### Authors' Response

*Nhess- 2020-279 - Cascade effect of rock bridge failure in planar rock slides: explicit numerical modelling with a distinct element code.*

Fig. 9. Histogram of the average altitude ("y" coordinate) of the OC contacts, for models 1 and 2 considering Scenario 3 (runs 2 times). N is equal to 18 and 46 respectively for model 1 and 2.

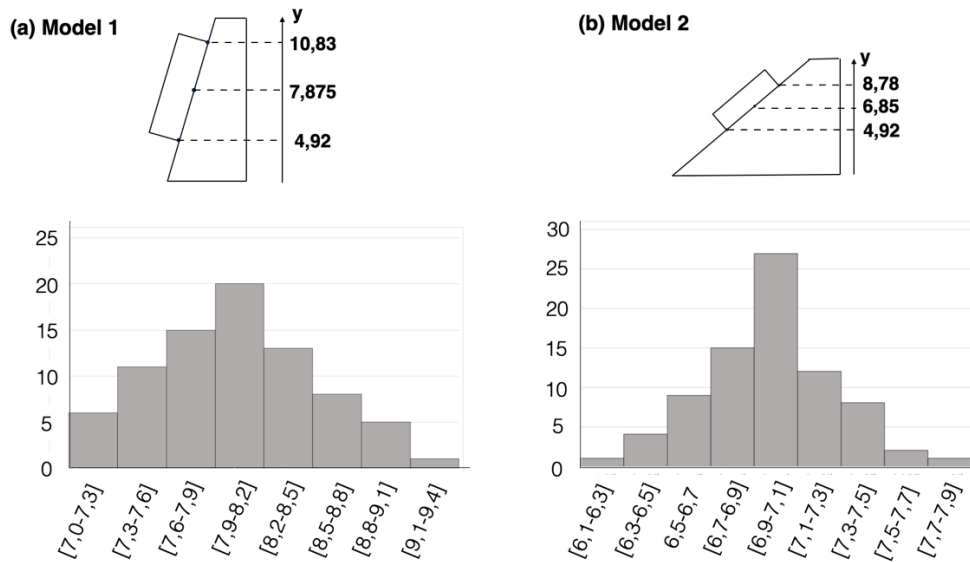
- **Response:** In all figures "the block does not stabilize" has been changed by "non-convergence of the simulation".
- Fig. 8. Wouldn't it be better to plot the height (better than altitude) of OC using the unstable block's base as reference? So, a length that spans between 0 and  $6 \cdot \cos(\alpha)$ ? In this way, it would be easier to compare the average height of the contacts with the block's median point. Why do you think in model 2 the average height of the OC that induce collapse is higher (7 m) than the median point of the block? And why they seem to coincide in model 1? This needs to be discussed. It would also be useful if you plot a histogram of the average heights. Finally, the unit of measures [m] should be indicated in the figure.

- **Response:** The Figure has been modified as proposed by the reviewer.  
Regarding the model 2, the presented line represents the average height of the OC (it may be confusing, the figure has been clarified). Same for model 1. In both cases, we are presenting the number of failed contacts for a same number of contacts defined as open crack

for the different simulation (18 contacts for model 1 and 46 contacts for model 2). It shows that the average location of these open crack has a direct influence on the number of rock bridges that failed due to increase of shear stresses along the joint.

A histogram has been added and discussed in the revised version of the paper and enclosed to this answer.
